ADDENDUM NO. 1

Bid #1506
ORANGE EDUCATION CENTER PORTABLES PHASE II
at
ORANGE EDUCATION CENTER

Project ID #3762, DSA #04-125366

ADDENDUM 1

NOTE: SEE SITE PLAN FOR EXACT LOCATION

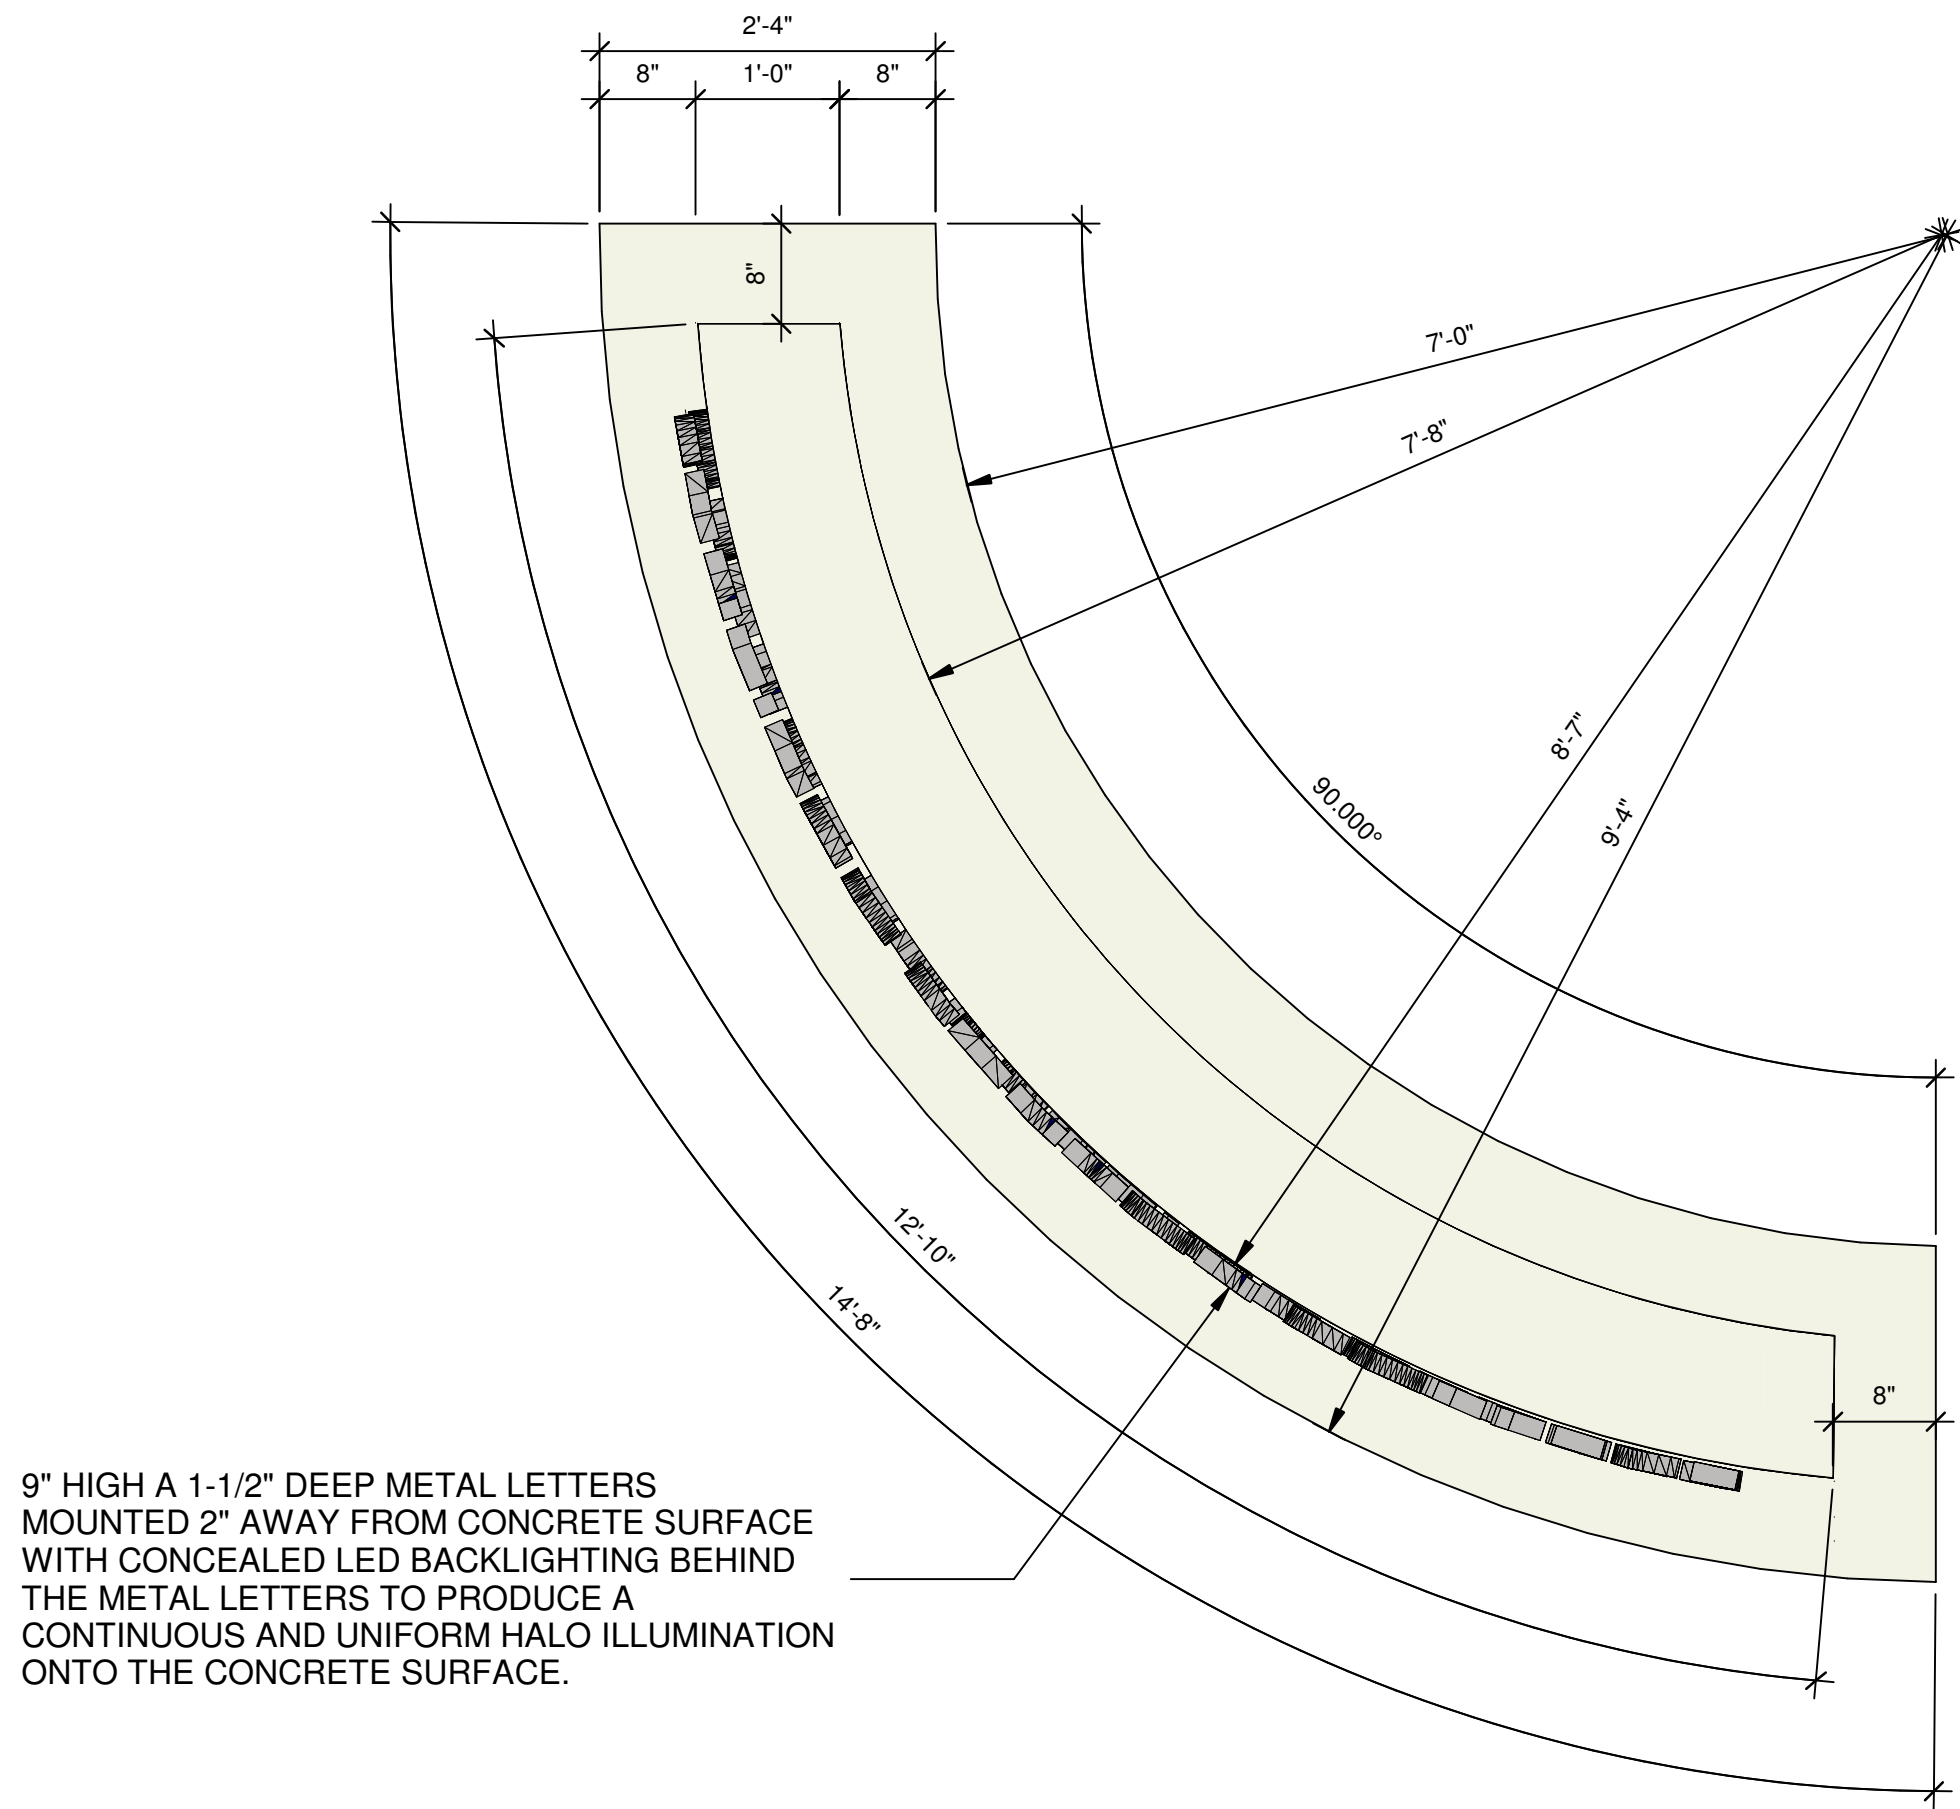
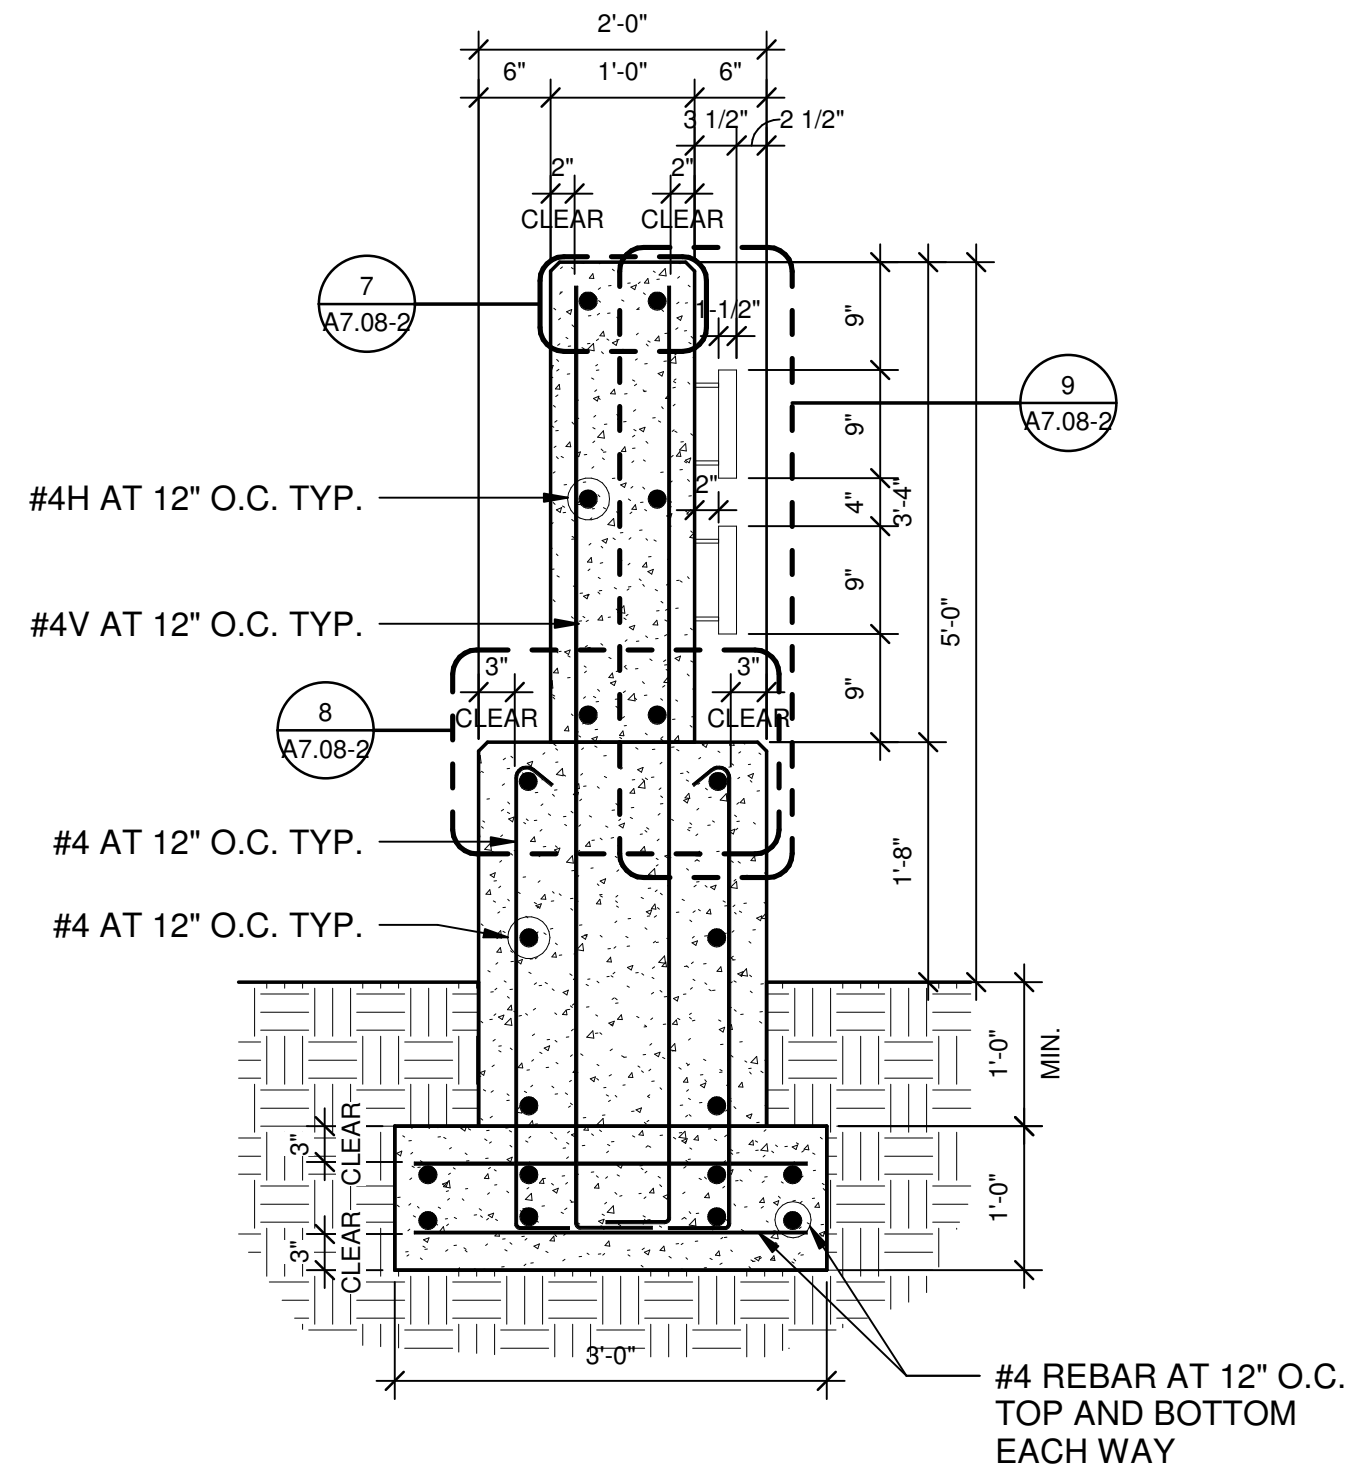
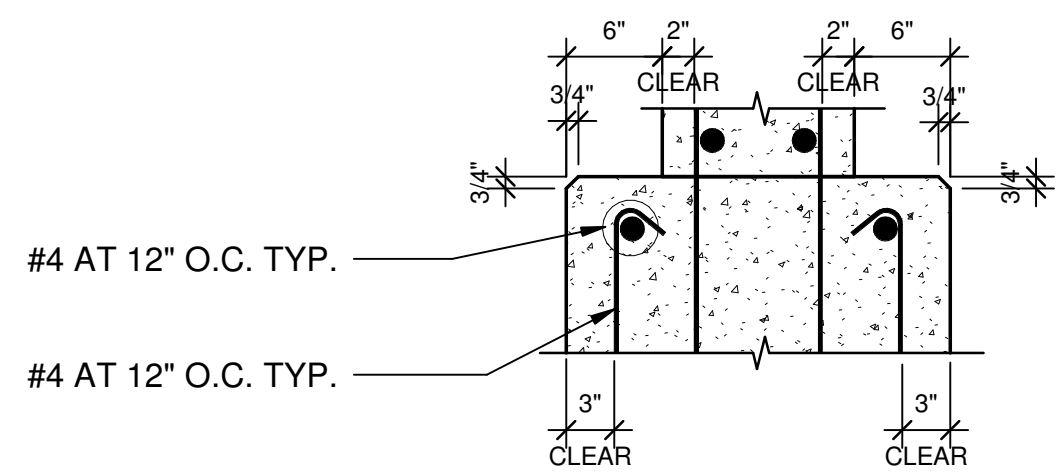
8. **A6.01-2:**
 - A. The detail for mounting methods of signage has been adjusted to clarify interior and exterior applications.
9. **A7.09-2:**
 - E. Sheet added for monument sign details.

P2.03-2

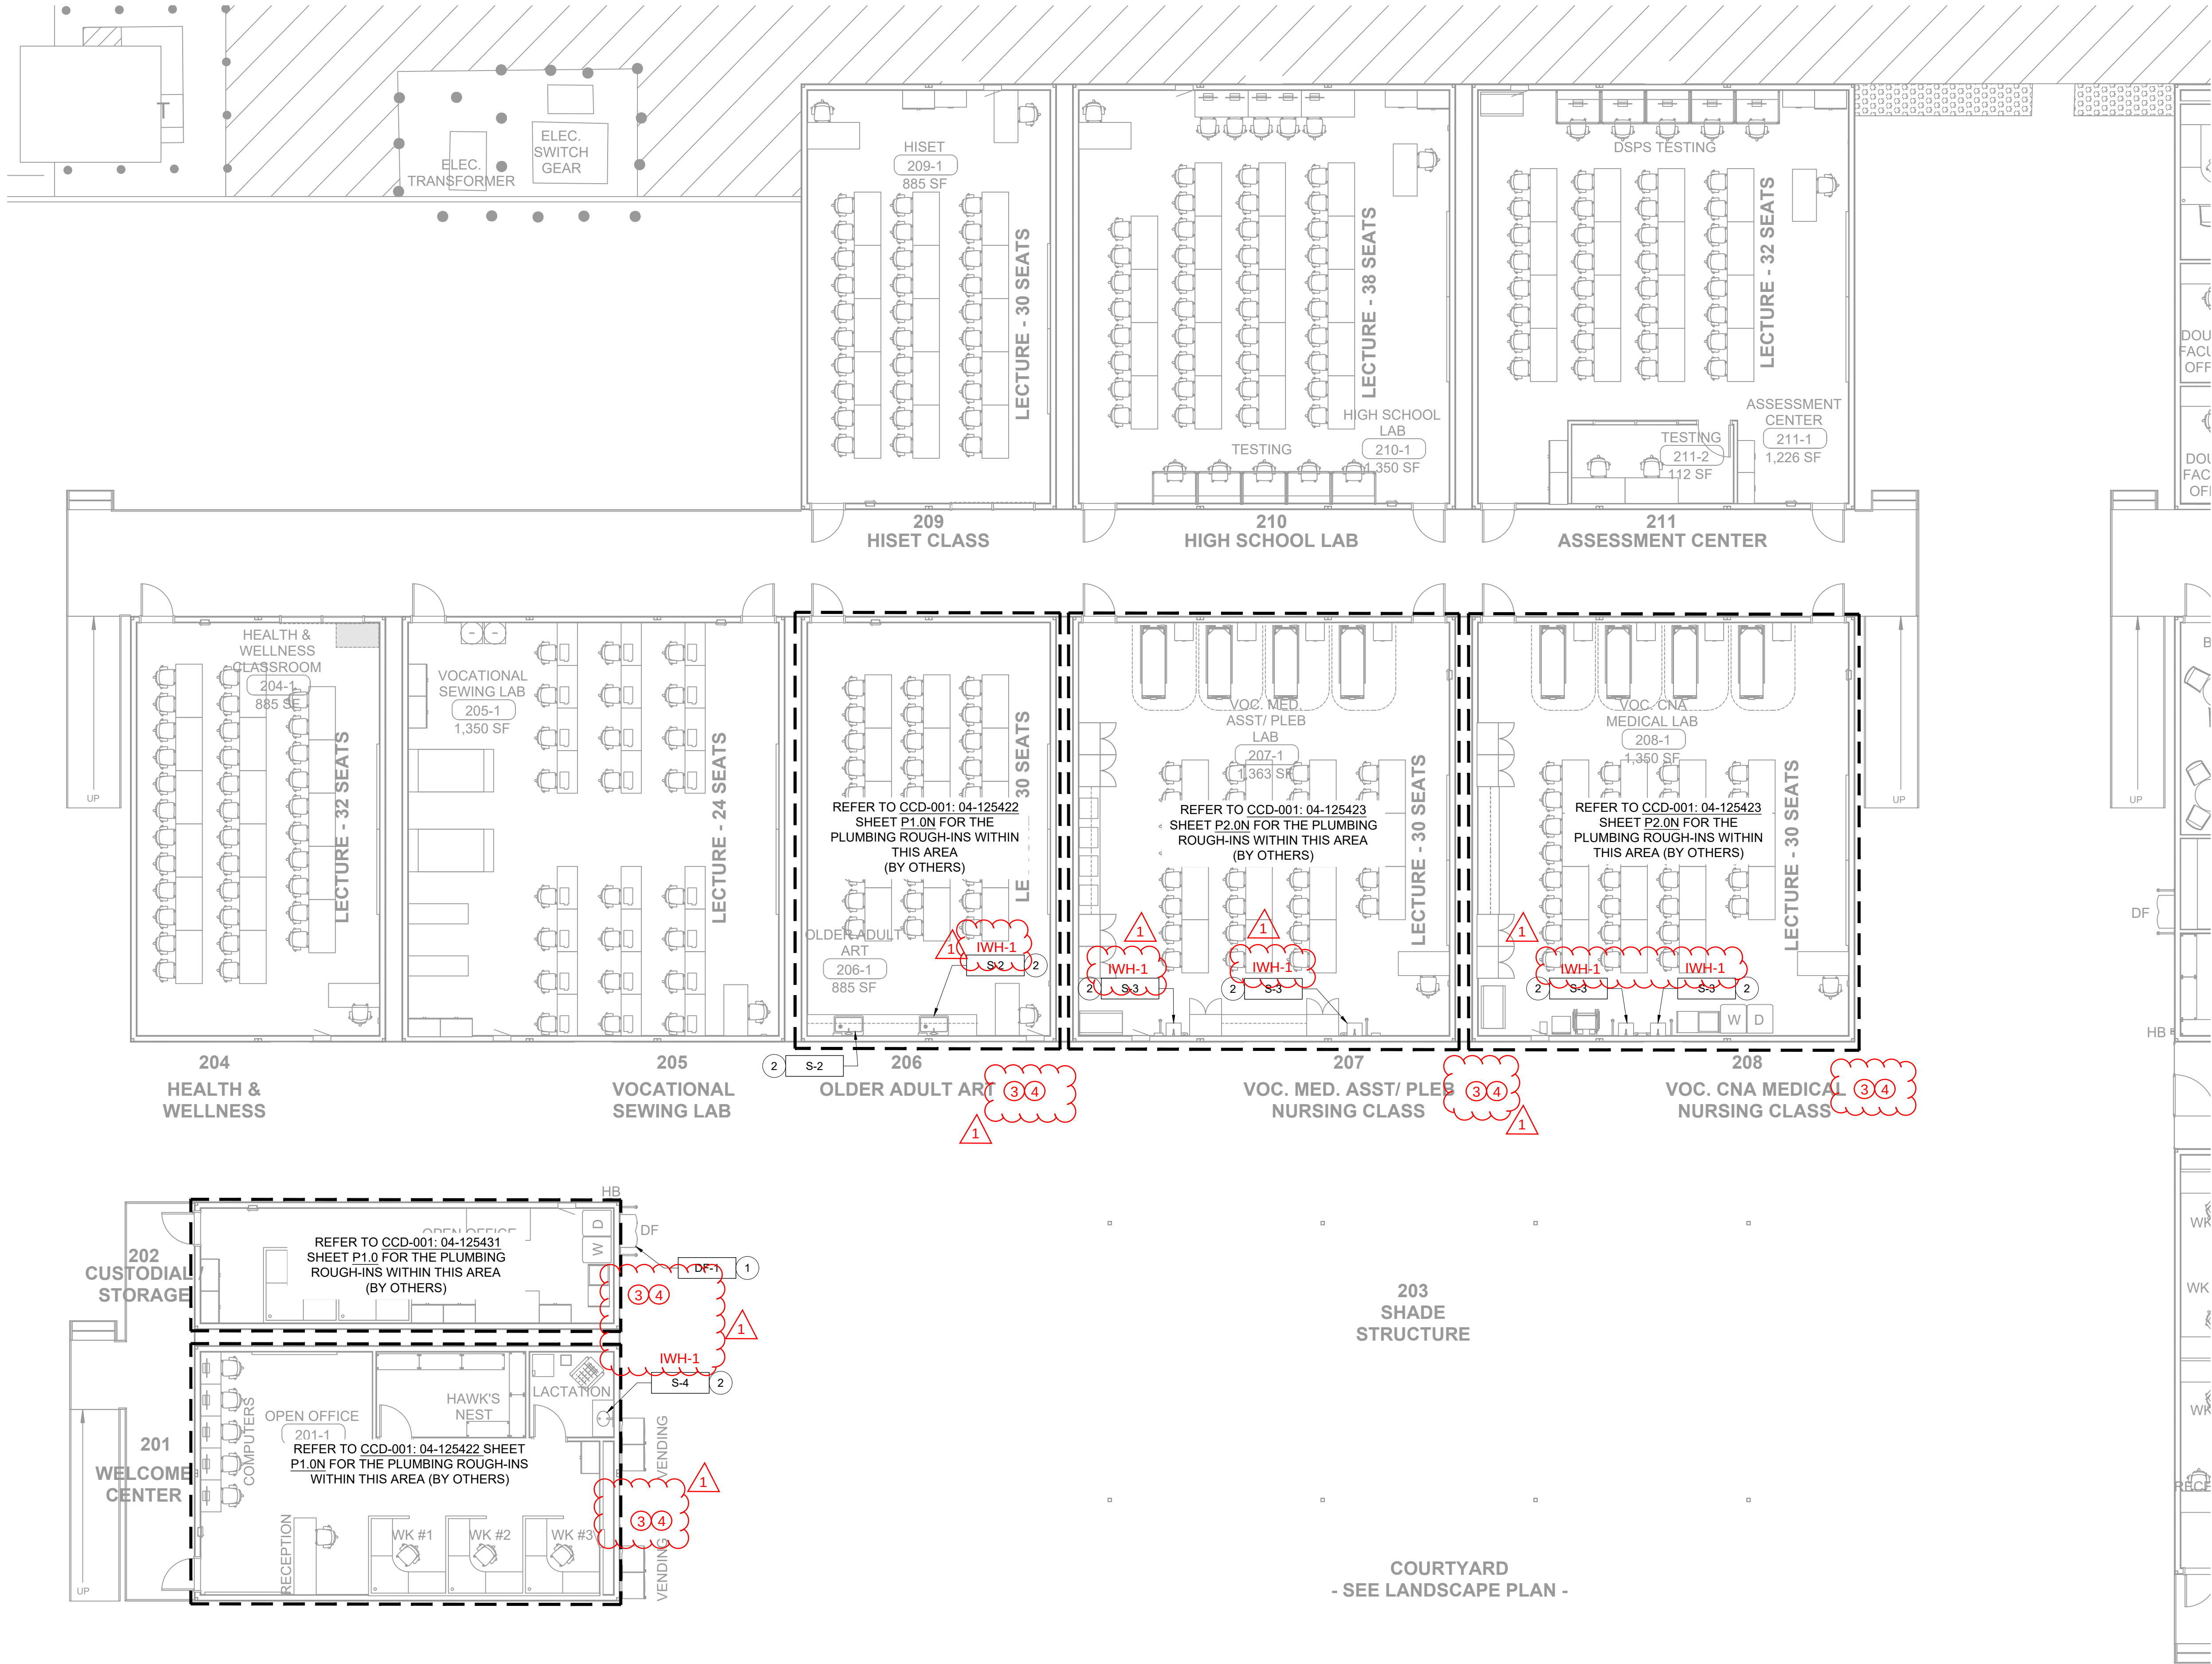
11. **P0.02-2**
 - A. Insta-hots water heater (IWH-1) is added to the schedule.
12. **P2.03-2:**
 - A. Installation note 2 updated to include furnishing & installation of the insta-hots for the sinks.
 - B. Installation notes 3 added on plans, describing that the contractor is responsible for furnishing and installing the main shut-off valve outside for each of the buildings.
 - C. Installation note 4 added on plans, describing that the final point of connections for the cold water and the sanitary sewer piping shall be facilitated by the contractor.
13. **P2.04-2:**

FA2.01-2

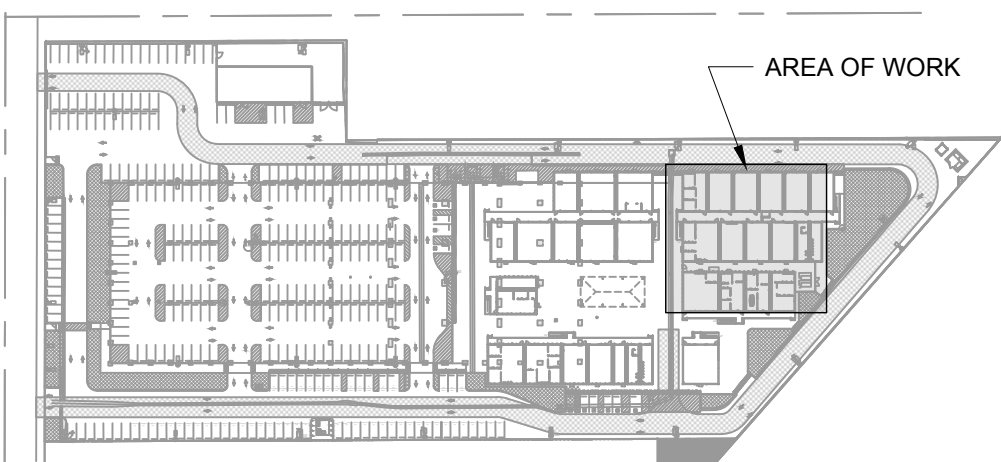
- 20. **FA2.01-2:**
 - A. Note added to heat detectors to note 3-0 ring will need to be installed by electrical contractor.
- 21. **FA2.02-2:**
 - A. Note added to heat detectors to note 3-0 ring will need to be installed by electrical contractor.
- 22. **FA2.03-2:**
 - A. Note added to heat detectors to note 3-0 ring will need to be installed by electrical contractor.
